**RESOLUTION HOLDING HEARING ON REQUEST FROM
HUBBELL REALTY COMPANY TO REZONE PROPERTY IN THE
VICINITY OF 1300 TUTTLE STREET, AND APPROVING PUD CONCEPTUAL PLAN**

STAFF REPORT TO THE PLANNING COMMISSION

Conceptual Plan Gray's Station, a Planned Unit Development in the City of Des Moines, County of Polk, State of Iowa
 Sheet 8 of 20

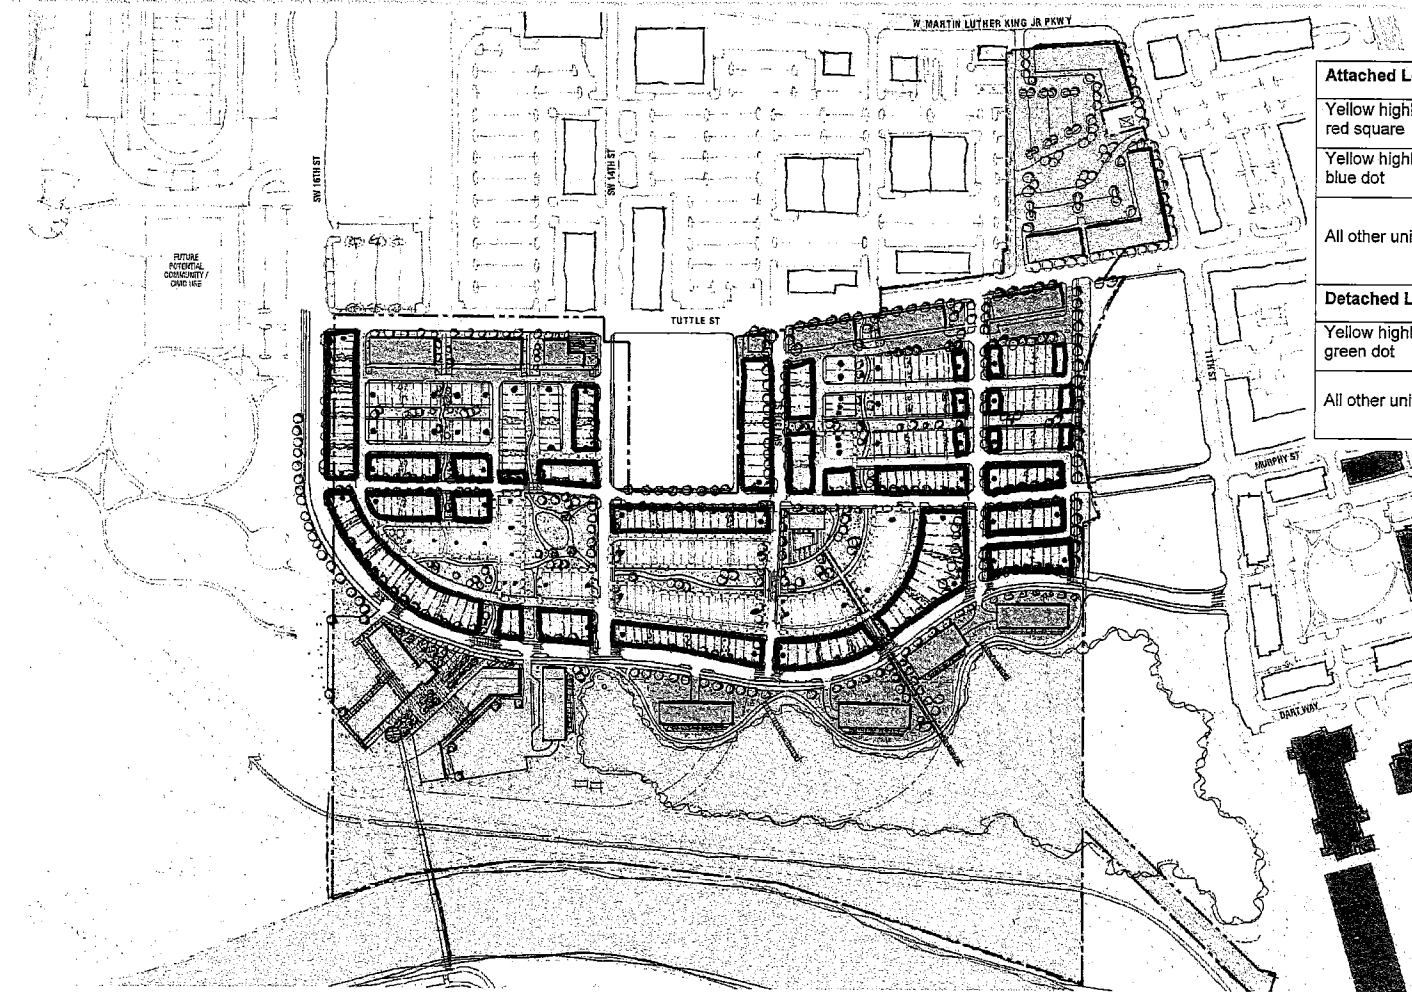
1. Sheet 2A – Design Guidelines
 - a. Item I(G) now states "detached urban townhomes shall be concentrated along green space areas and neighborhood park areas and be limited to the subareas as illustrated on the Conceptual Illustrative Master Plan on Sheet 8."
 - b. Item III(A)2 now includes language that prohibits the use of vinyl on the exterior of buildings.
 - c. Item IV(G)3(a) now states "minimum height for all uses shall be one story except as indicated on the Conceptual Illustrative Master Plan on Sheet 8."
2. Sheet 8 – Conceptual Illustrative Master Plan

- a. Has been updated to identify where detached and attached dwellings would be constructed within the Medium Density Residential areas.
 - b. Has been updated to identify 34 attached dwelling lots that would be required to have a 2-story minimum height within the Medium Density Residential areas. These lots are noted by a red dot.
3. Sheet 10 – Conceptual Phasing Diagram
- a. The phasing plan has been adjusted to consist of 3 phases instead of 6 as originally proposed. The phases move from east to west and each phase consists of multiple land use types.
4. Sheet 18, 19 and 20 – Prototypical Building Illustration Sheets
- a. The building frontage requirements on these sheets have been corrected to match the building frontage requirements list in the Design Guidelines portion of the Conceptual Plan.

6. Revision of the PUD Conceptual Plan to reflect the drawing titled "Staff Recommendation Attachment."

Included in the Plan and Zoning Commission packet is a marked-up version of Sheet 8 titled "Staff Recommendation Attachment." This attachment and associated chart illustrate where staff believes it is vital to require higher standards than proposed for the Medium Density Residential areas.
